8.1 List of Validation Studies and Proposals

Following the Checkpoint Presentation, and after rating the ideas, the VE team analyzed several validation studies and prepared several specific proposals.

The following pages contain the validations and proposals studied along with As Designed cost and VE Proposal cost. The results were presented to MDOT on Thursday, March 18, 2004. For the attendance list and copy of the presentation see Appendix C.

Exhibit P6.3

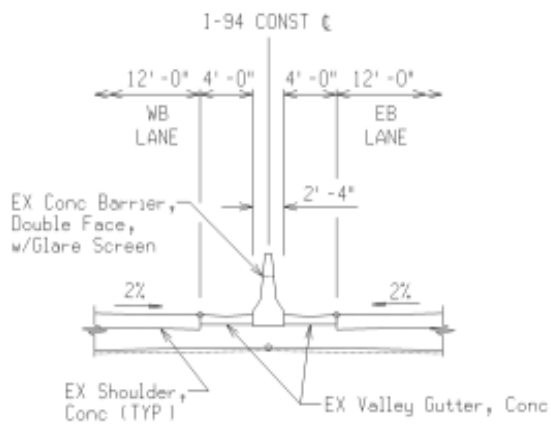
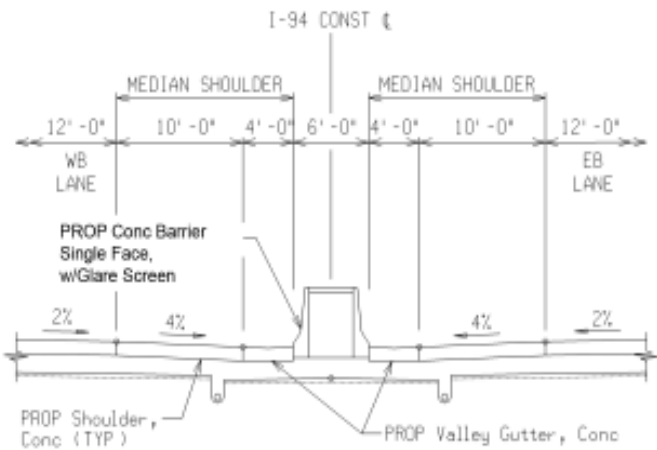
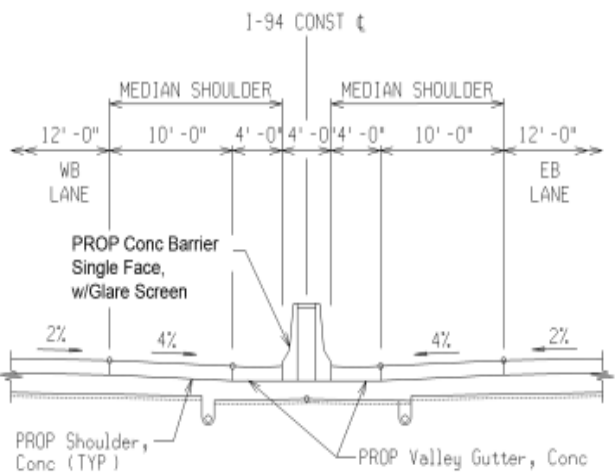
The current DEIS calls for a 6'-0" split median barrier with 14'-0" median shoulders.

Place a 4'-0" wide median barrier and 14'-0" shoulders the entire project length. This will provide a consistent median width and the 4'-0" barrier would be wide enough to accommodate the center bridge piers without having to taper in and out. The cost of this VE Proposal is as follows:

Assume 15% reduction in Phase I unit price for concrete barrier to account for narrower paved surface, less fill and less subbase.

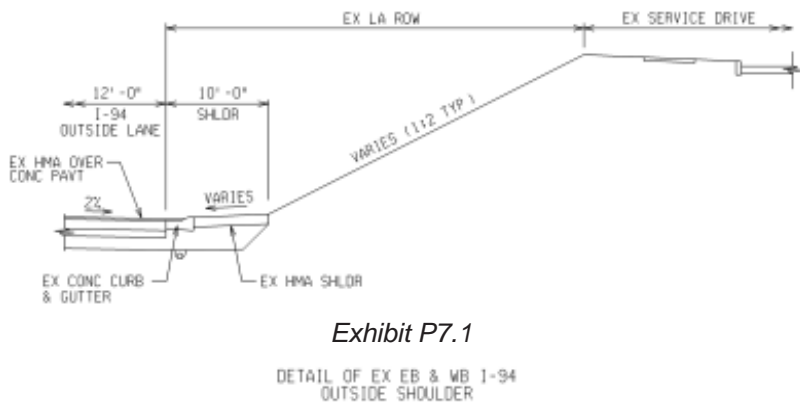
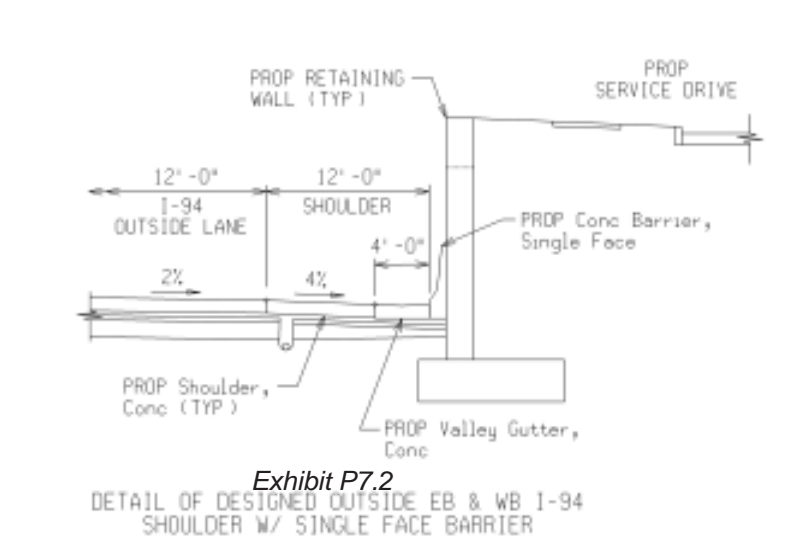
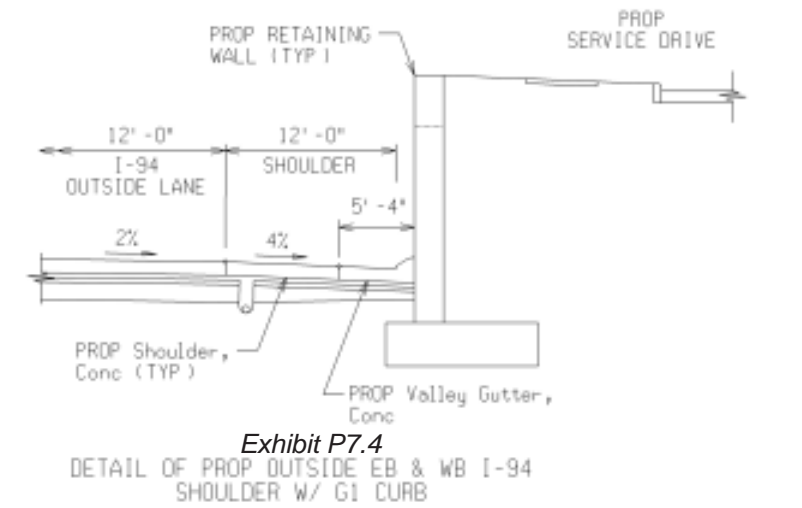
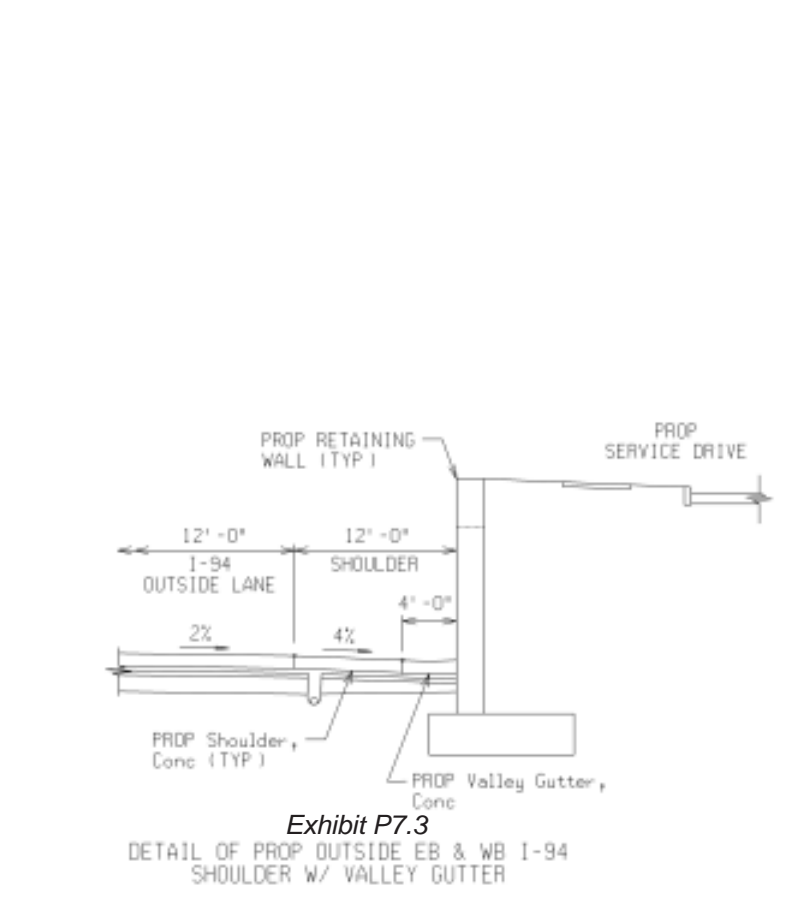
The current DEIS details a flush 12'-0" shoulder out to a single face barrier against a retaining wall up to the service drive grade.

Construct a flush 12 ft. outside shoulder with a valley gutter as part of the shoulder or use a G1 curb with gutter pan as part of the shoulder located adjacent the retaining wall.

Exhibit P8.1

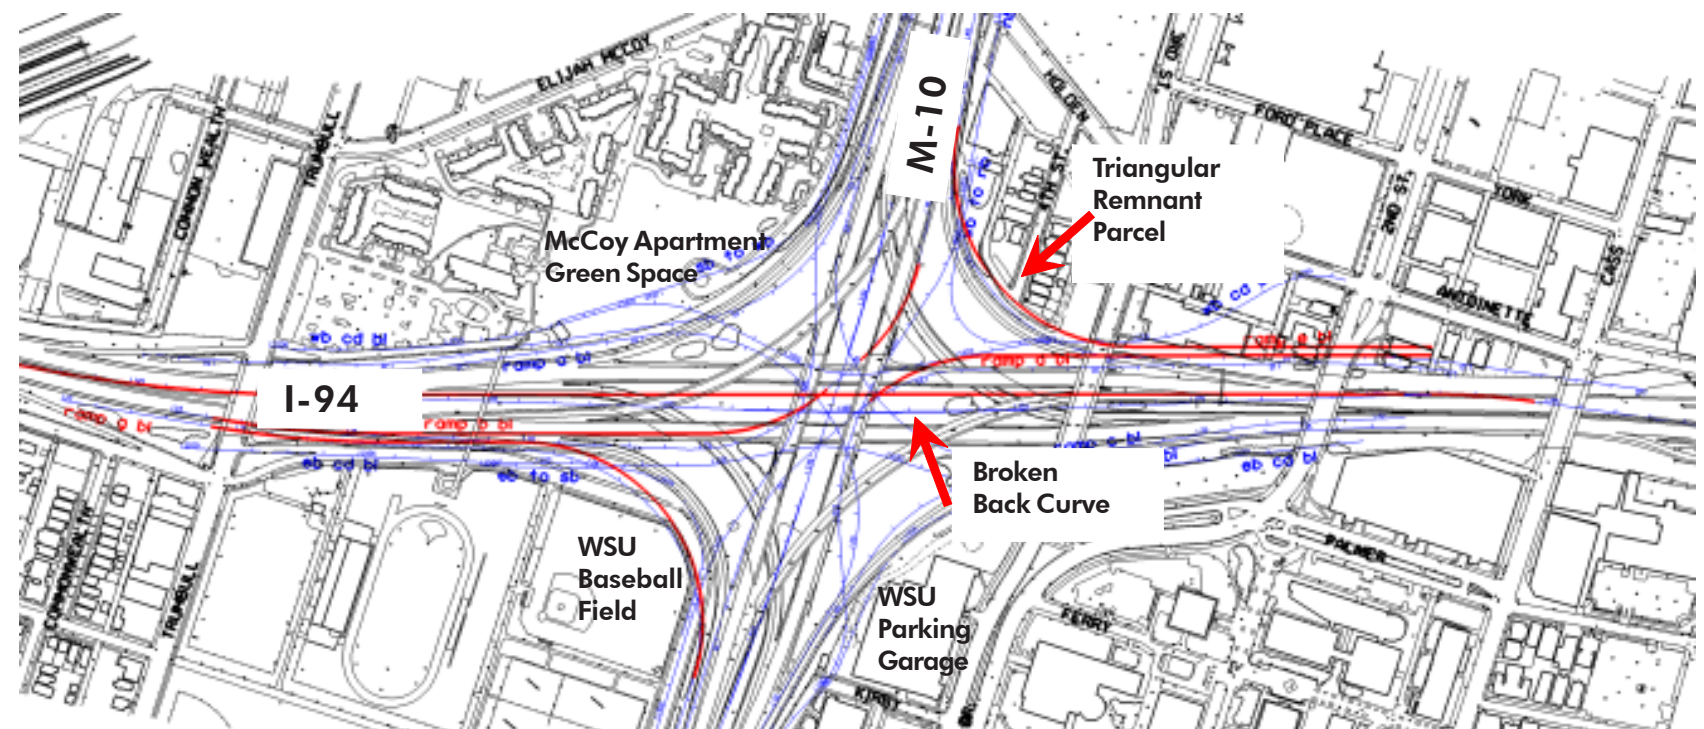
The alignment of I-94 from east of Trumbull to east of 2nd Street can be simplified by eliminating the 11,500 ft. radius horizontal curve within the interchange. The modification would begin just east of Trumbull by lengthening the proposed 4,000 ft. radius curve near Trumbull. A new "ahead" tangent would be established that is the "common" tangent to the curve at Trumbull and the 2 degree 45 minute curve at 2nd Street. The 370 ft. curve at 2nd Street would be shortened to 291 ft. by this change. The revised alignment for I-94 and several ramps is shown in red on Exhibit P8.1.

The shift of I-94 to the north allows the EB exit to NB and SB M-10 to also shift. The exit is currently parallel to I-94. As the I-94 bearing is rotated to the north, the exit ramp could be moved further away from the field. This will allow more room for the EB to SB ramp, which is currently proposed with a 510-foot-radius. This radius is the minimum allowed for a design speed of 40 mph with 6% superelevation. This change, in conjunction with other alignment revisions, would reduce the impact on the existing right-of-way of the baseball diamond. The shift would also provide additional clearance between the exit ramp and the EB service drive to facilitate the structure and retaining wall.

Exhibit P10.2
VE Proposal

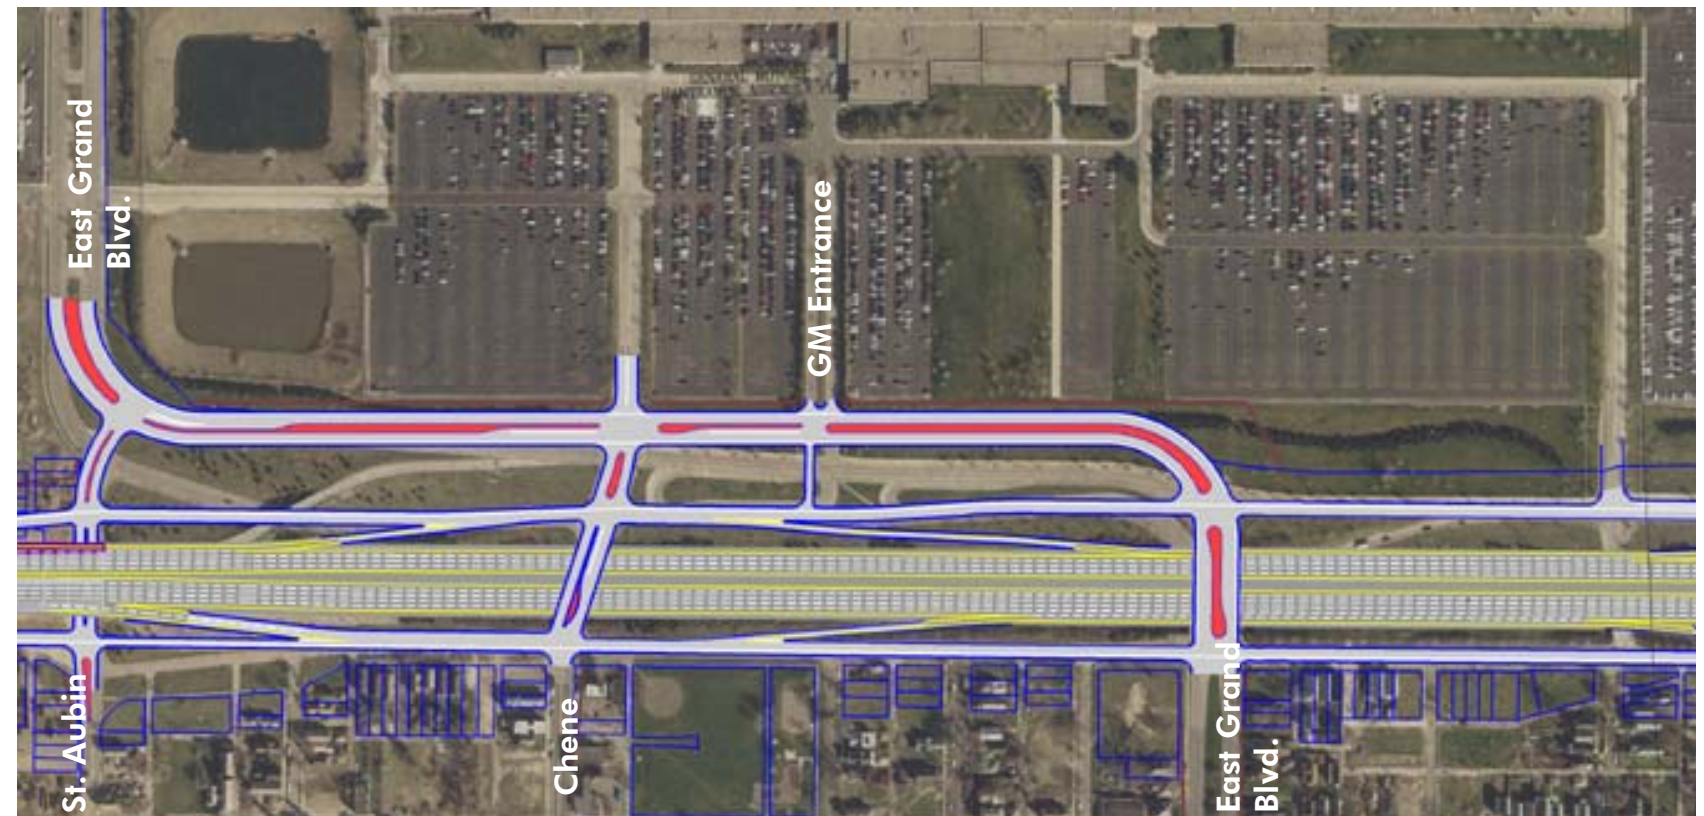
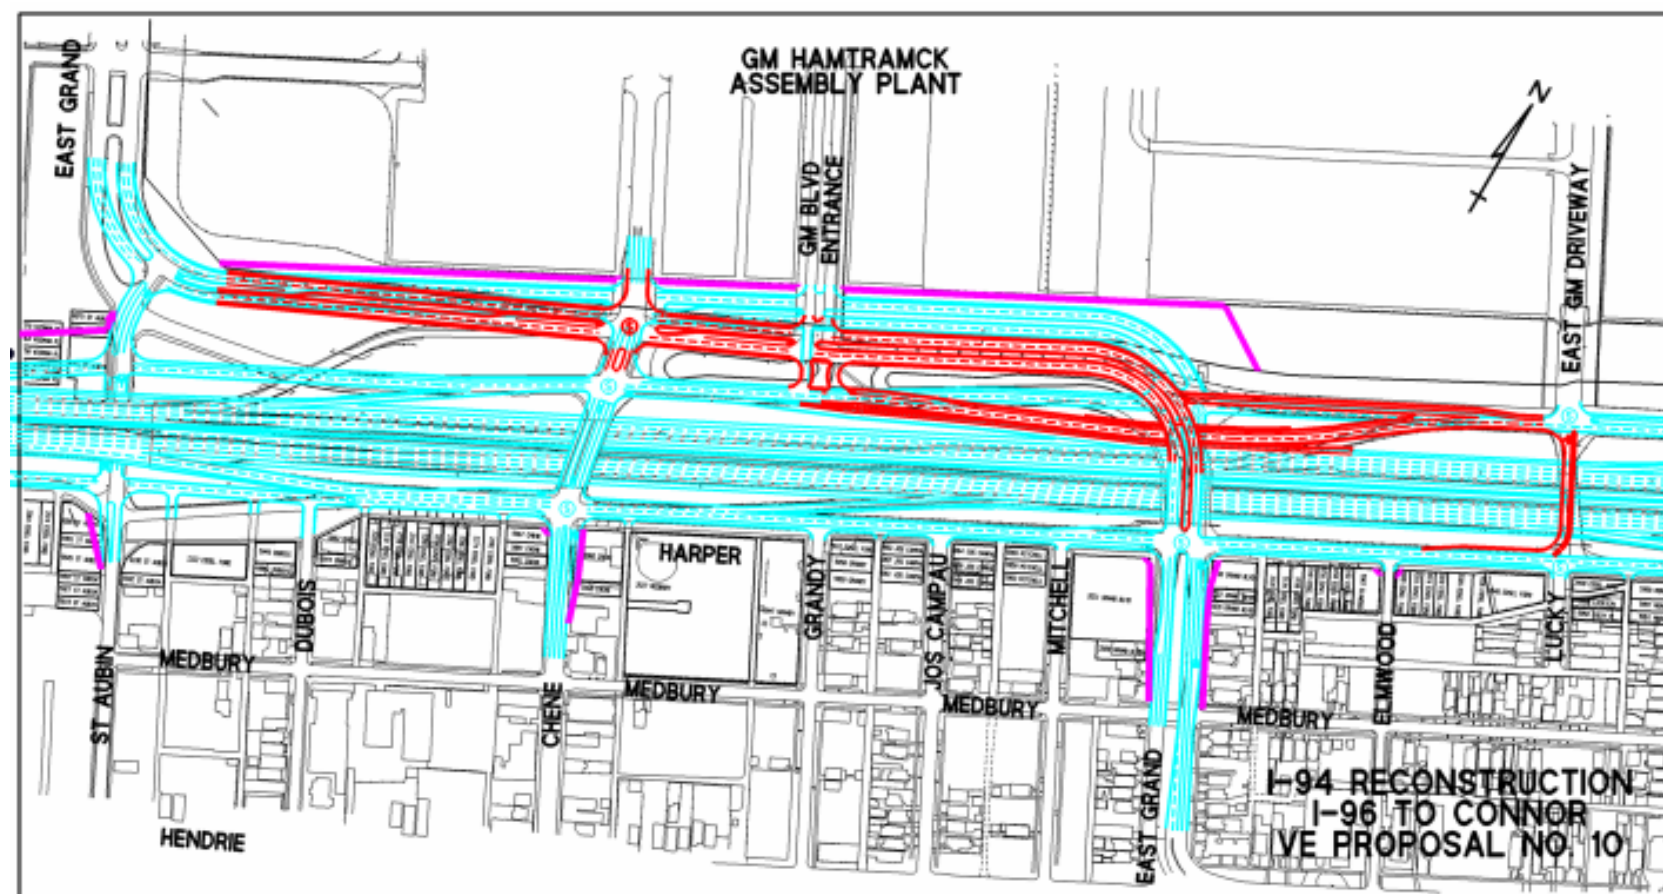
An opportunity to reduce or eliminate the need for ROW from GM was recognized during the VE Development Phase and gives MDOT an alternate means to provide the same functionality in this location if problems arise during ROW negotiations.

DETAIL OF MEDIAN EB & WB I-94 w/ 2'-4" MEDIAN BARRIER

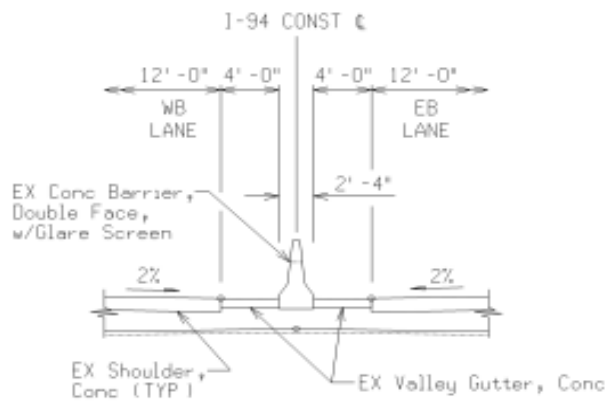
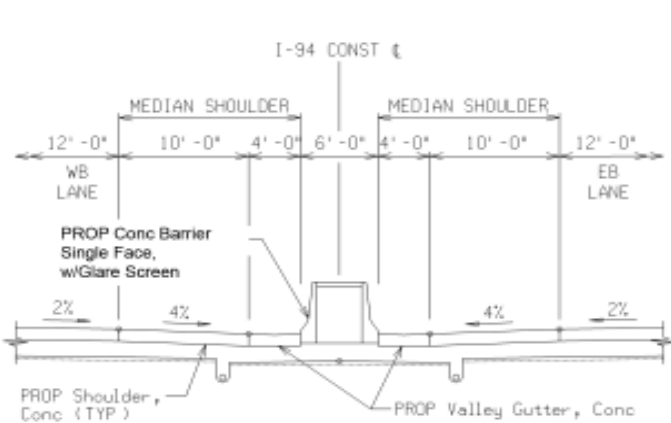
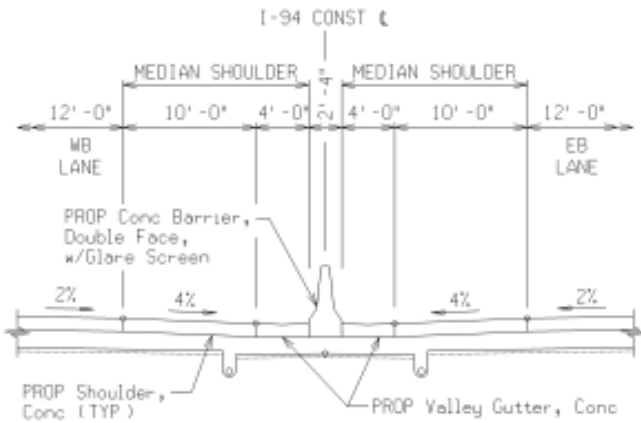
The current DEIS shows a 6'-0" (split) median barrier with 14'-0" median shoulders.

Place a standard 2'-4" wide double face median barrier with 14'-0" median shoulders the entire project length. When bridge piers or large sign foundations are located in the median the median barrier would be tapered out per standards and the 14'-0" median shoulders reduced in width by one to two feet at the pier or sign. The median barrier could be widened to 6'-4" and still maintain the minimum required 12'-0" median shoulder. This option would reduce bridge costs and provide more area along the frontage road. The disadvantage is that the barrier width would vary

through the corridor. The 2'-4" width is current MDOT practice and would still provide a 12'-0" median shoulder.

Exhibit P12.2

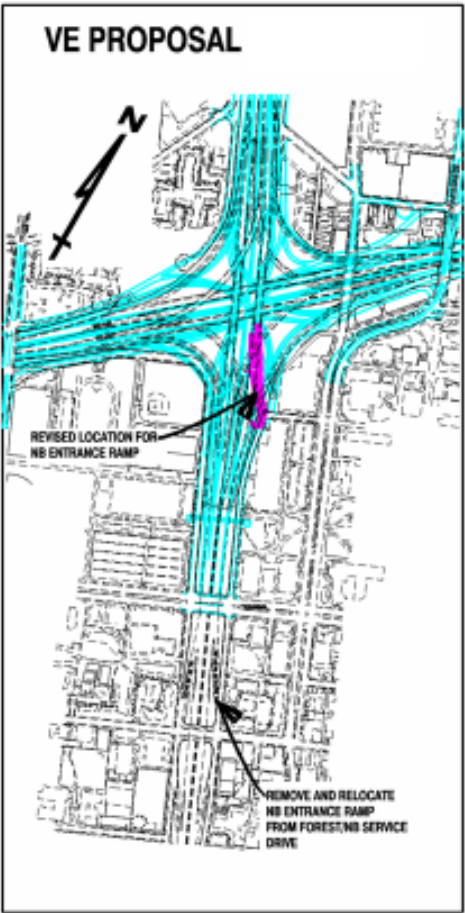
- As revised during the past seven months, it is proposed to fully remove the existing SB exit ramp to Forest since a SB exit ramp is already proposed at location only 1800 feet to the north. However, traffic along EB and WB I-94 that desires to exit in the vicinity of Forest will now need to exit at other ramps. EB and WB traffic destined for the WSU campus area will need to exit at the ramps prior to Trumbull and then use the EB service drive.

- The extension of the SB auxiliary lanes to Grand River, and the attendant retaining wall construction, can be deferred until future reconstruction of M-10.
